Wollongong Local Planning Panel Assessment Report | 9 April 2024

WLPP No.	Item no. 3
DA No.	DA-2023/367
Proposal	Mixed use - demolition of existing structures, tree removal, construction of eight (8) storey shop top housing development, basement parking, associated earthworks and landscaping, Subdivision - Torrens title - two (2) lots, and land dedication for footpath widening
Property	300-302 Crown Street Wollongong
Applicant	Albert Zhang - Truland Development Pty Ltd
Responsible Team	Development Assessment and Certification - City Centre Major Development Team (NL)
Prior WLPP meeting	N/A

Assessment Report and Recommendation

Level 7

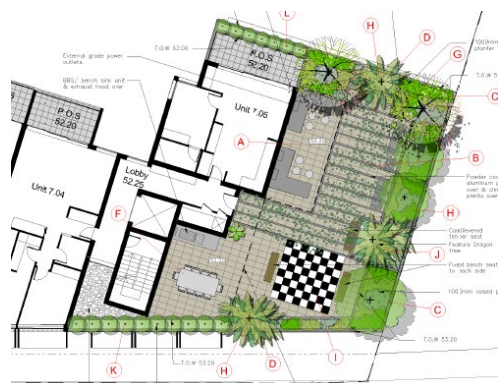
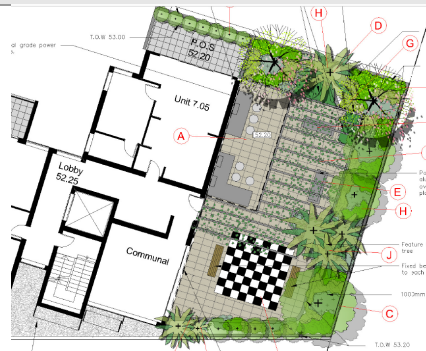
Explore opportunities to reduce paving and maximise planting on both level 1 and level 7 communal spaces. Harness opportunities to create seating nooks that cater for both groups and individuals.

Explore amenity across both communal spaces to maximise use of residents. Consider providing outdoor gym equipment, table tennis, raised vegetable gardens and edible plant species near BBQ areas for outdoor cooking.

It is recommended that larger planter widths are provided along Crown Street edges to minimise noise and pollution impact from street below.

The Landscape Plan has been updated as shown below. Planting beds have been widened in select areas. Both levels have separated seating areas. Outdoor gym equipment has not been integrated however the building is not of a scale that warrants this. Communal vegetable gardens would likely become a maintenance issue and not be practicable. The planter along the level 7 COS area has been widened slightly and an enclosed communal room added.

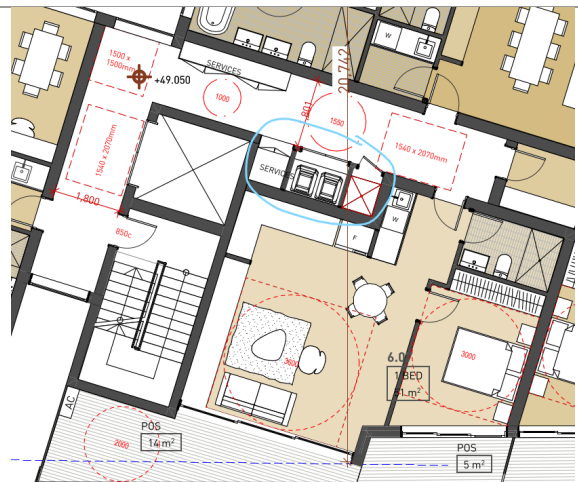
Consideration should be given to relocating the services cupboard in the eastern core to allow the proportions living space to units 107 to 607 to be improved. A more rectangular living space, that can accommodate well-proportioned dining/ kitchen area may be possible if the services cupboard were located on western side of the fire stair.

This has not occurred for the following reasons:

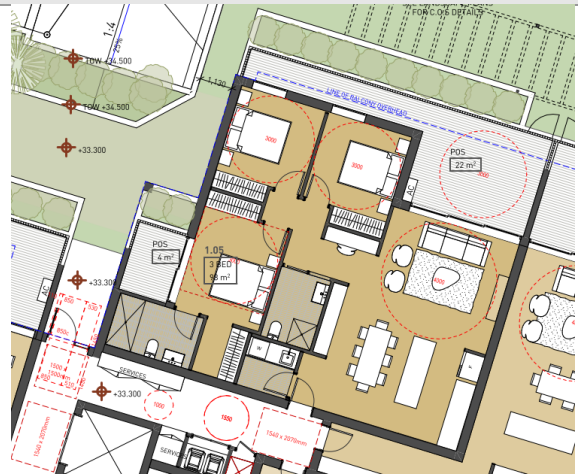
The privacy of unit 105 (particularly bedroom 3) is compromised by the proximity and narrow proportions of the circulation path from Waters Place on the level 1 COS. Unit 105 should be reconfigured to mitigate potential privacy issues and provide more generously proportion circulation space within the COS.

This bedroom has now been set back into the building, and a fenced courtyard with landscape buffer has been provided to create privacy between the COS and this unit.

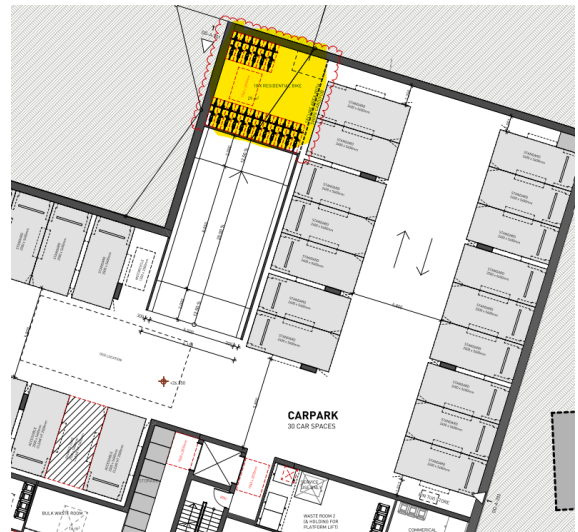
Bicycle storage half a level above vehicle access is inconvenient. Access via the lifts is inappropriate.

The residential bicycle storage has been moved to the carparking side of the level C1 basement. This means that it can be accessed via the vehicle ramps without the need to use the lifts to get to the storage.
